Attn: *Laurie Connors, Director*
RE: *Peer Review for Site Development Plan at
192 Millbury Avenue, Millbury, Massachusetts
BEI Project No. 21M-170
Mass DEP File No. 224-0826*

**Peer Review
Millbury Planning Board**

Parcel Identification Number: 23-047
192 Millbury Avenue
Millbury, Massachusetts

(Revised November 17, 2021)

DESIGNED BY: R. G. Murphy DATE: 6-25-2021
DRAWN BY: R. G. Murphy DATE: 6-25-2021
SCALE: 1" = 20' SHEET: 3 OF 3

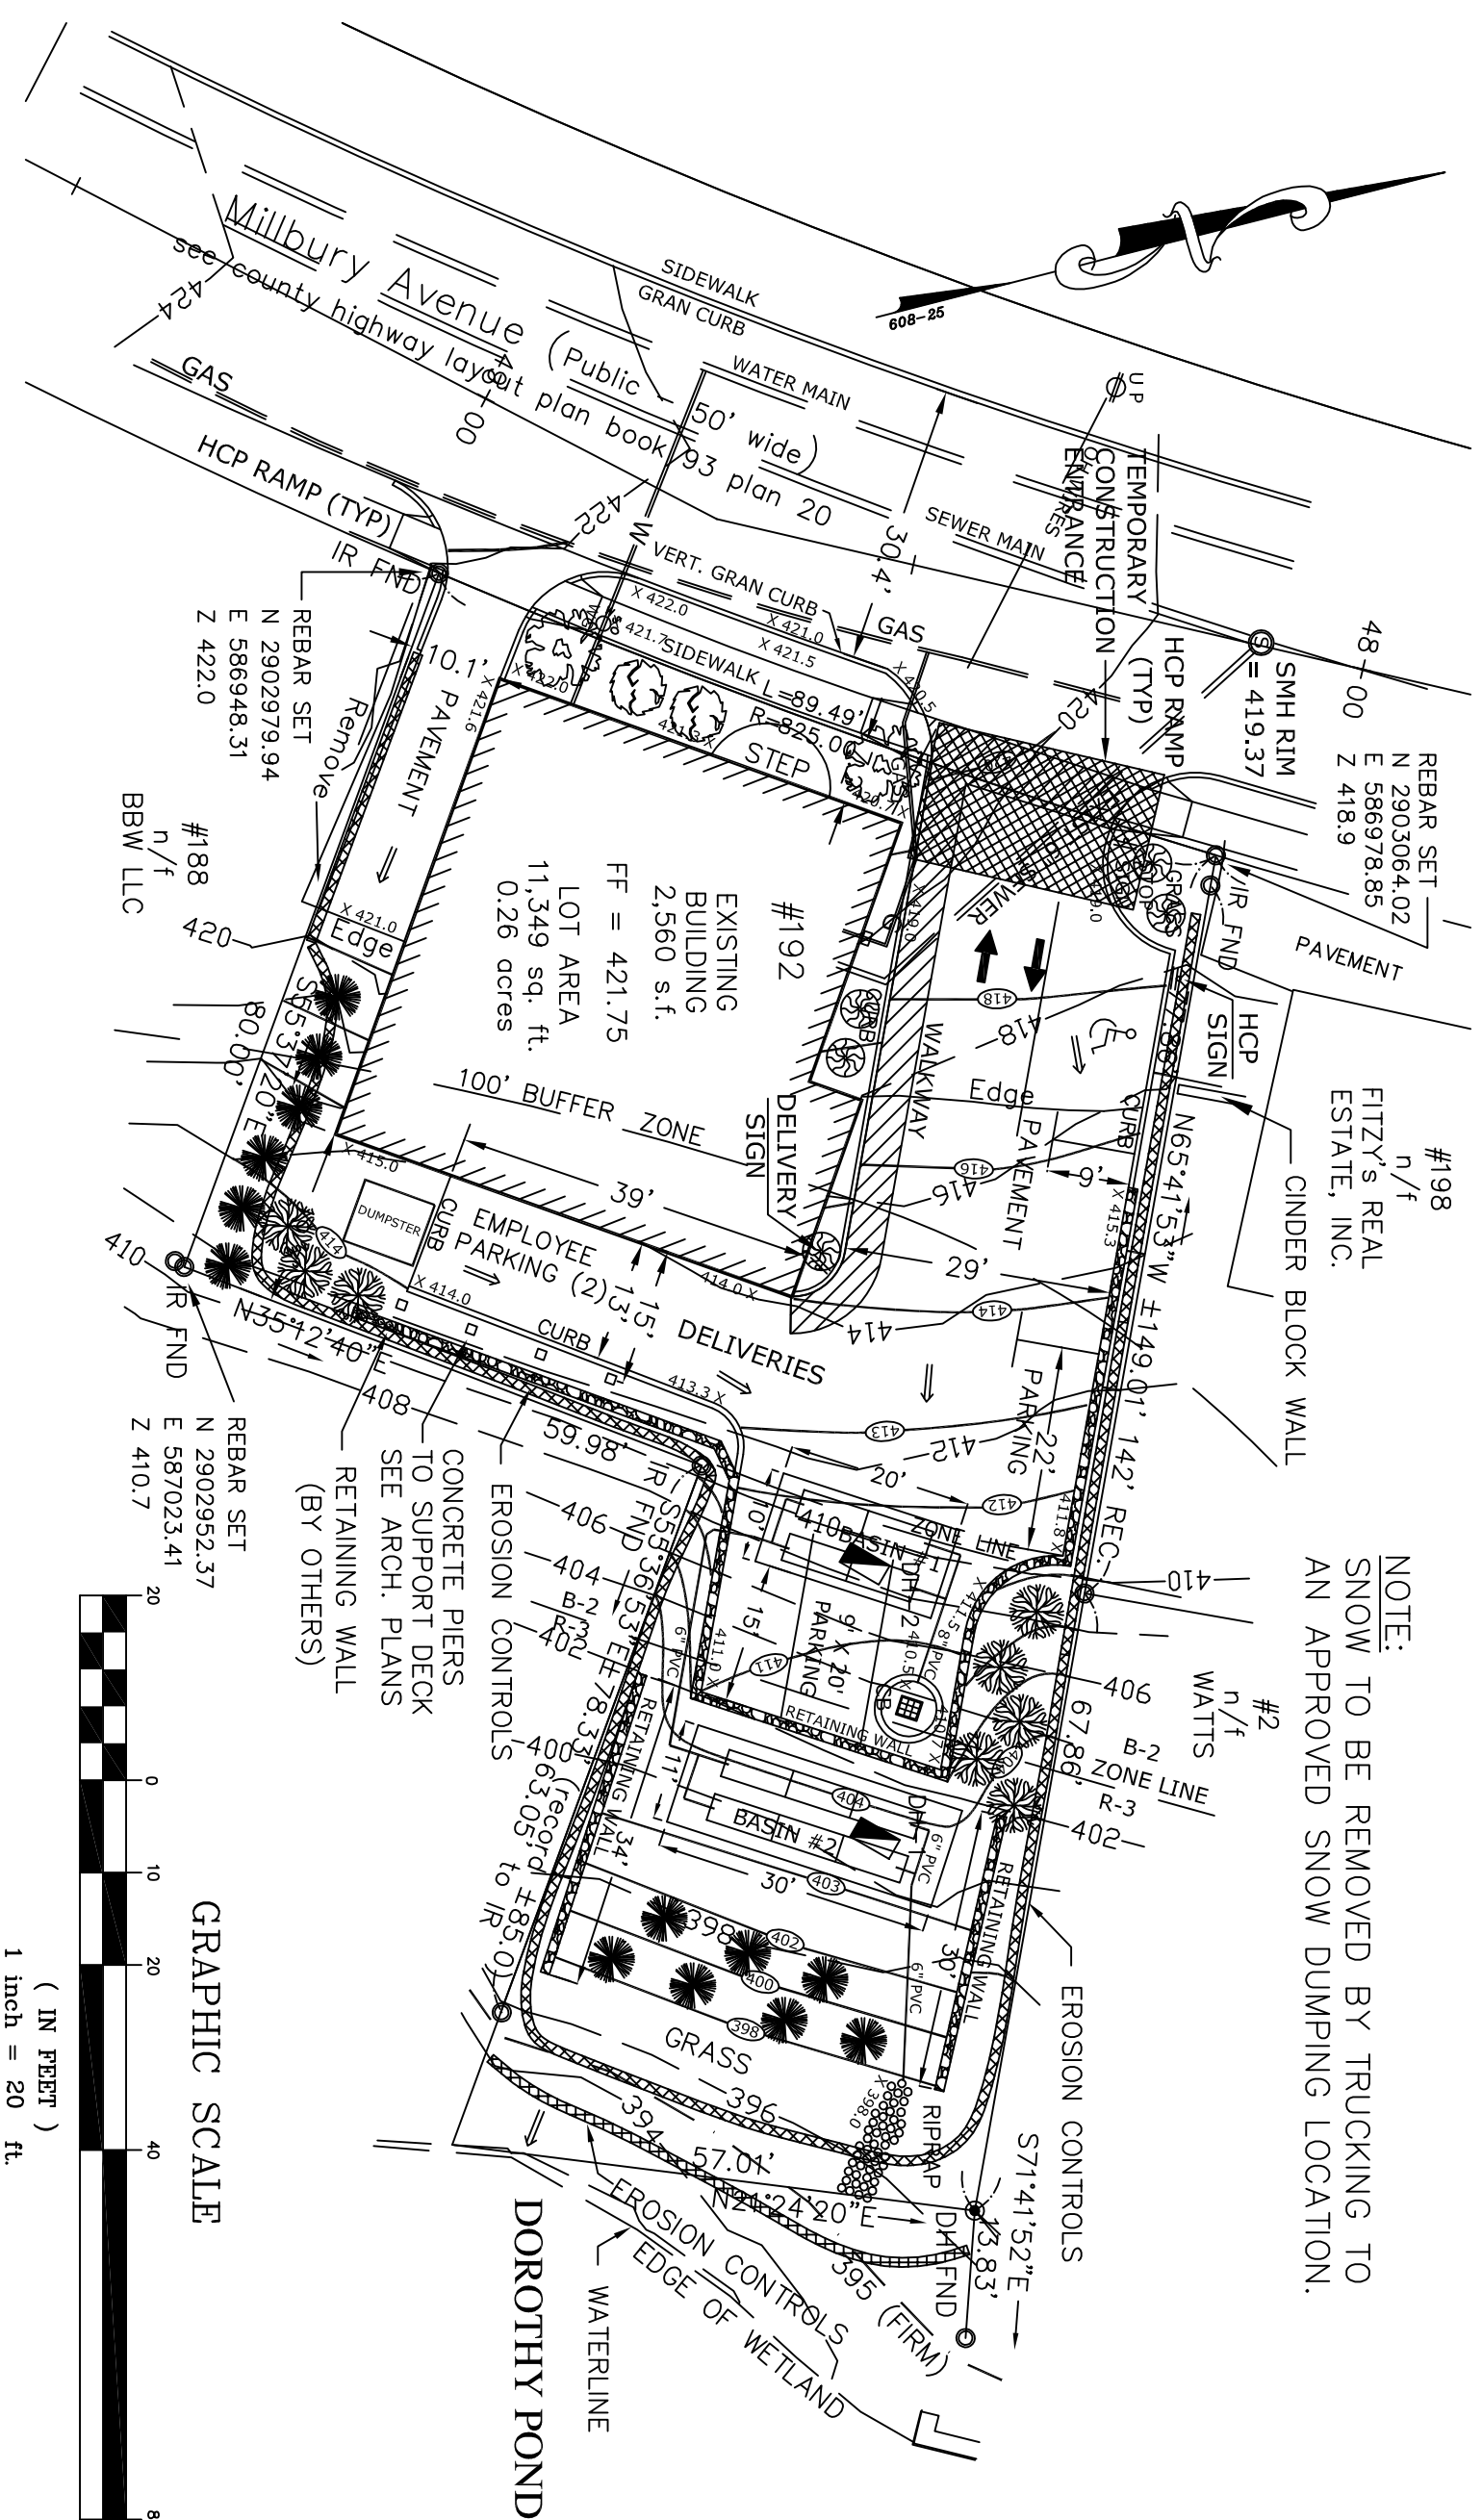
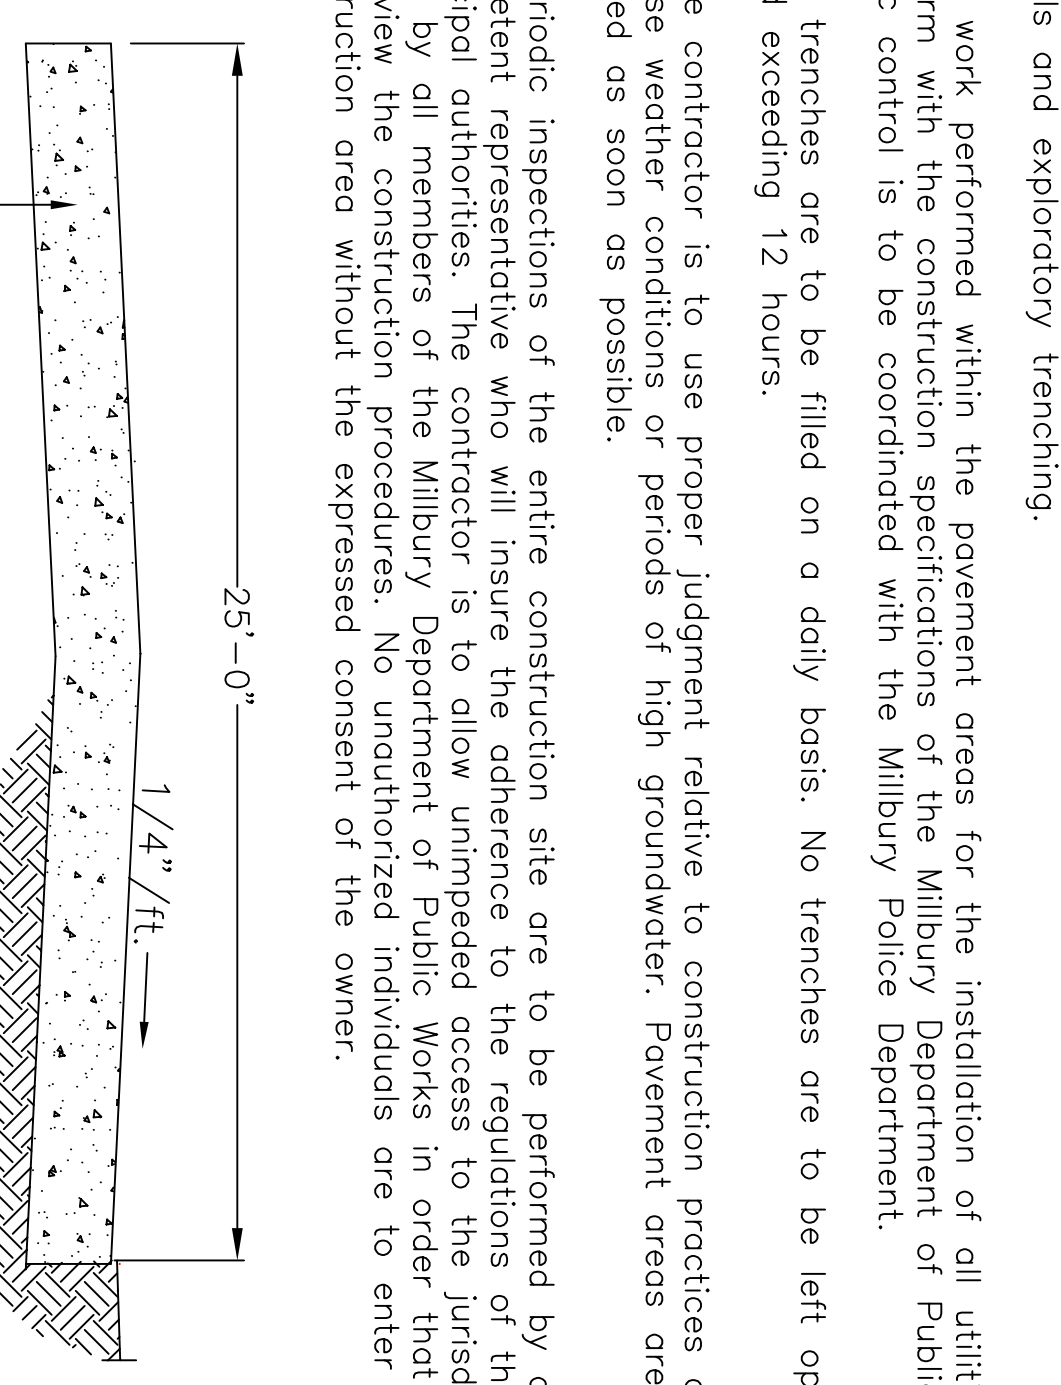
6. Lighting and Photometric Plan was not provided with the Site Plan submission. We recommend this item be addressed by the applicant.
7. Parking calculations on sheet 3 of 3 identify nine (9) proposed parking spaces. Stantec recommends the applicant provide documentation to support the proposed number of parking spaces as required per Section 33. Parking and Loading Requirements. We also recommend pavement markings delineating the parking spaces be shown on the plan and provisions for handicap accessible spaces be addressed by the applicant.

1. Landscaping: As shown on sheet 3 of 3, proposed grading includes fills between 2 and 6 feet within the site. As such, retaining walls are proposed along the northerly and easterly property line in varied height between 2 and 5 feet. We recommend the applicant provide final designed stamp drawings of the proposed retaining walls and evaluate the need for a guard rail adjacent to the proposed parking areas. We note segments of the proposed retaining walls are approximately 2 feet off the property line and question the need for temporary construction easements from the abutting properties.

- Soil logs 1 and 2 have been provided on Sheet 3 of 3, entitled Landscape Plan. The seasonal high groundwater elevation has only been provided for both basin locations.
- Existing and proposed ground cover and runoff coefficients have been provided in the Stormwater Report.
- A drainage area map showing pre and post conditions have been provided in the Stormwater Report.
- A sequence of construction has been provided in the Stormwater Pollution Prevention Plan. We recommend the construction sequence be added to the Site Plan.
- Stantec recommend cross section of the proposed two subsurface chamber systems identifying items such as existing and proposed grades, refusal and/or seasonal high groundwater be provided on the plans.
- Provide calculations regarding the average annual load of Total Phosphorus and estimated pollution removal

HANDICAPPED RAMP DETAIL N.T.S.

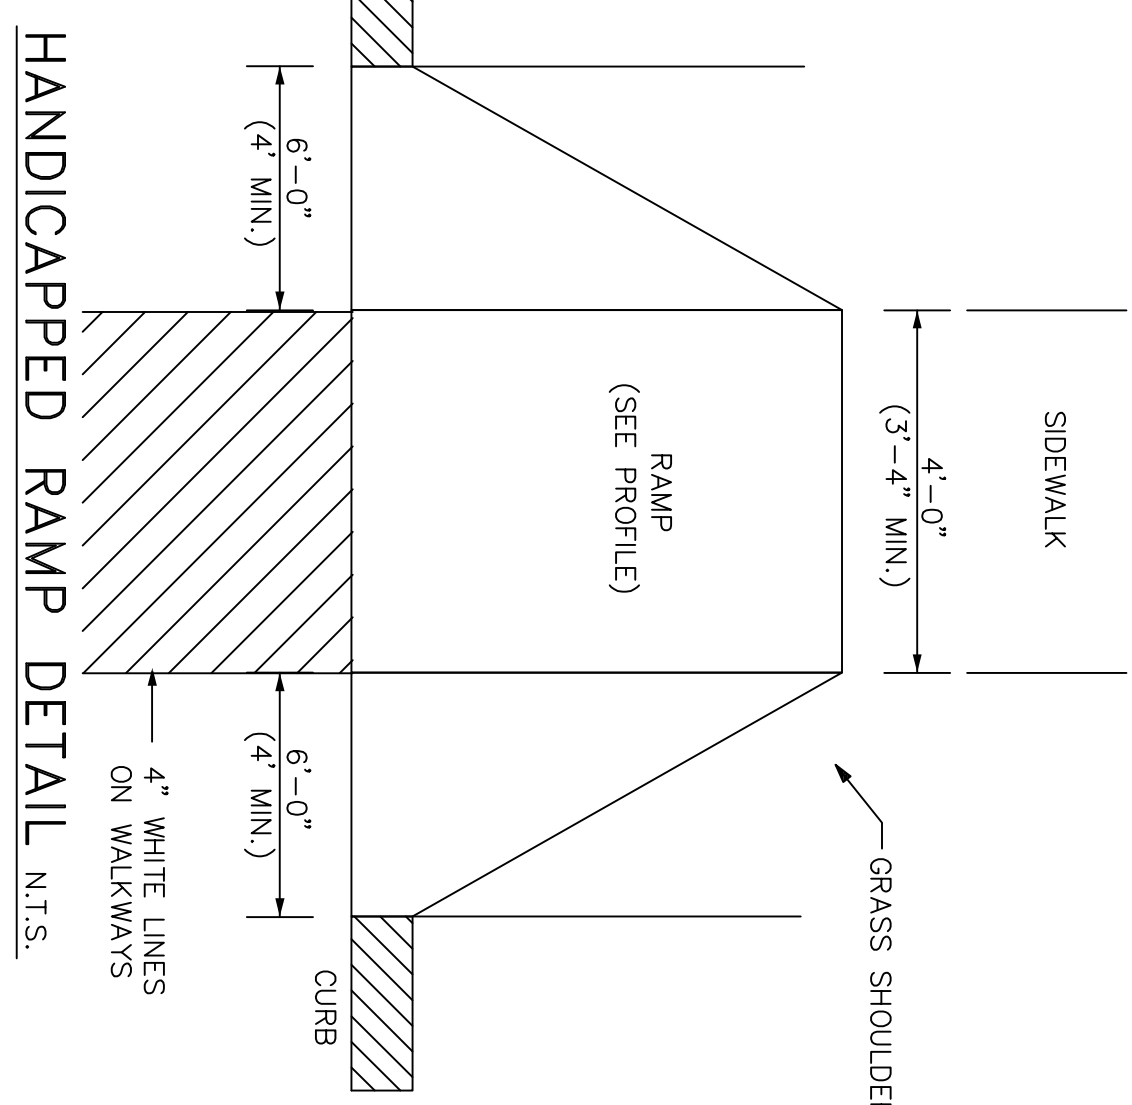
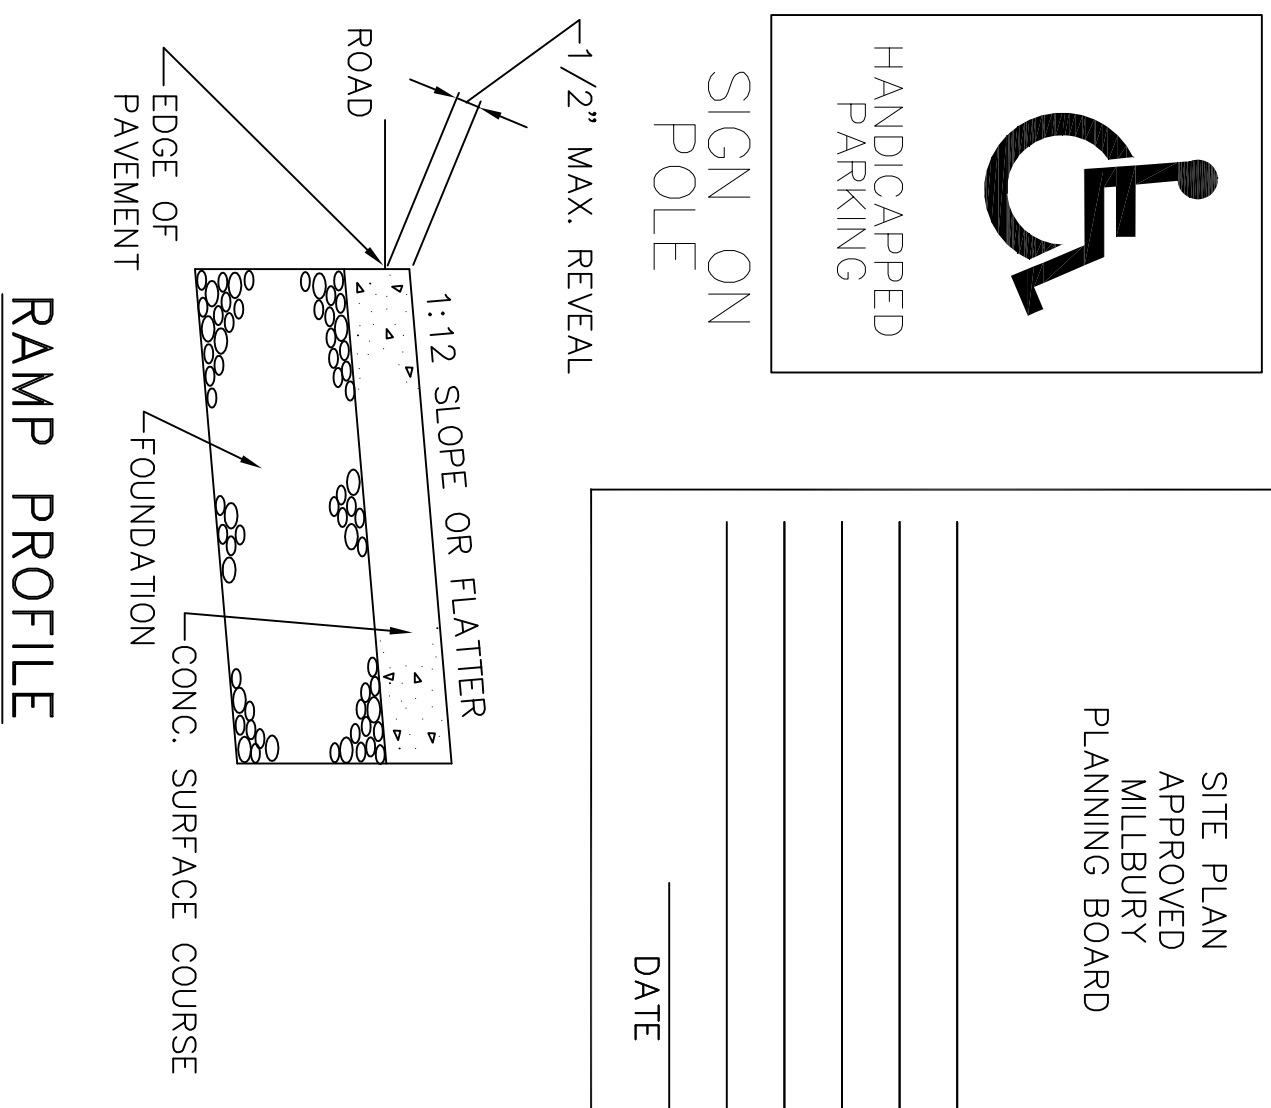
BEI Comment 7: 6.13 –The parking area grades from the accessible parking space to the public sidewalk, do not comply with 521 CMR ABB & PROWAAC, Chapter 5.
